March 20, 2017
Minutes – Regular Meeting of the Board of Commissioners

PB 13-12 Moyock Commons, Phase 1
Preliminary Plat/Use Permit
Zoning

C113

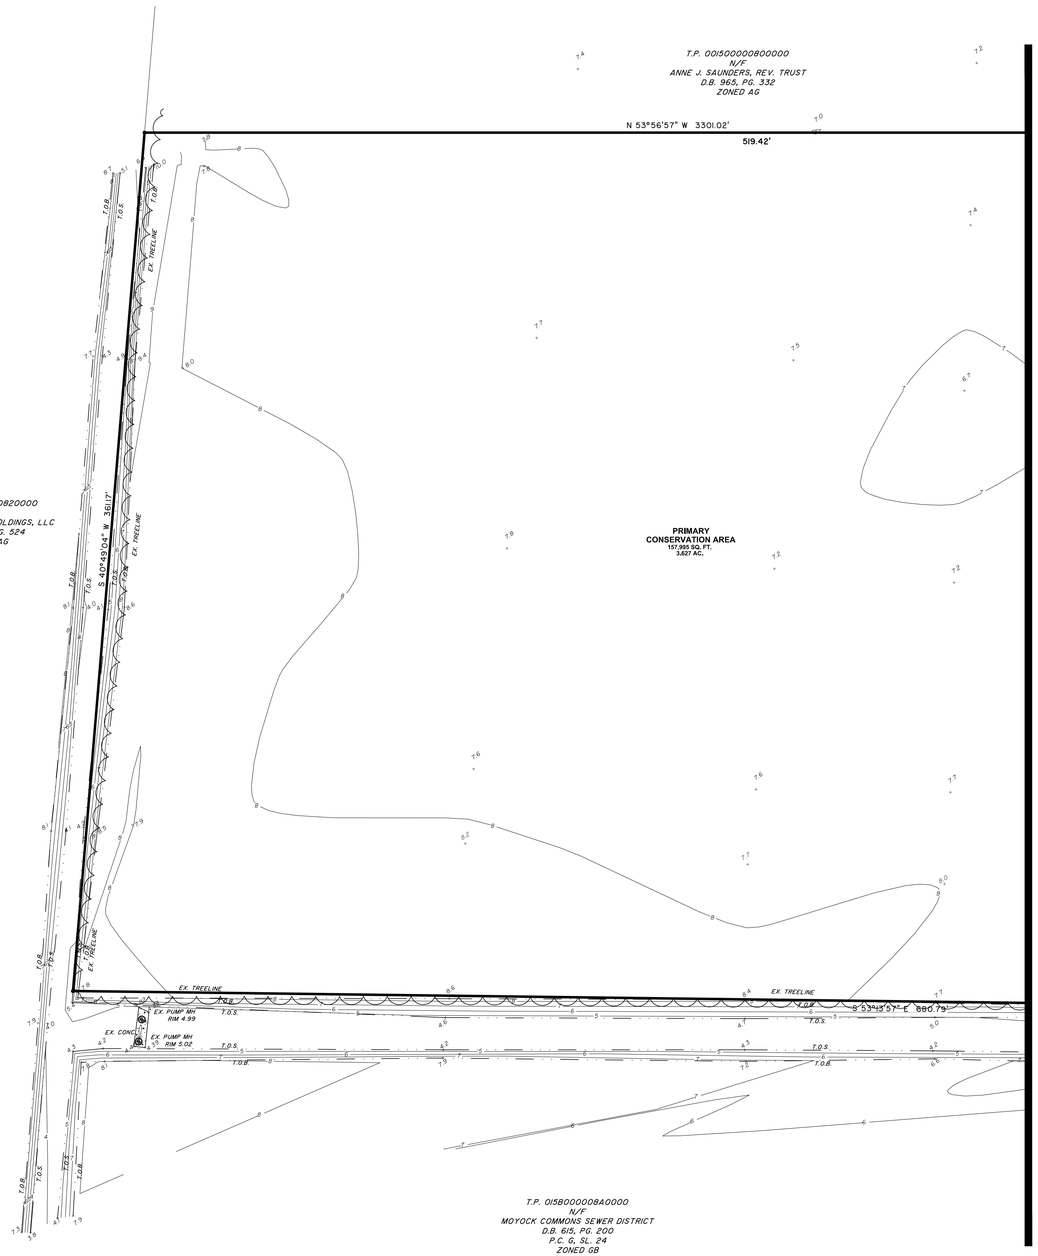
- General Discussion:
  - Lake benches proposed for environmental quality and safety
  - Road side ditches in R/W and drainage easement along lot frontages
  - Improvements along 'E' Street as shown on attached Sheet C113 to include new culvert under Puddin Ridge Road to increase the drainage efficiency of Ditch #4
  - Small diameter stub pipes are proposed to drain ditches from the Voliva Property (189 Puddin Ridge Road) that would otherwise be blocked by proposed pond outfall pipe
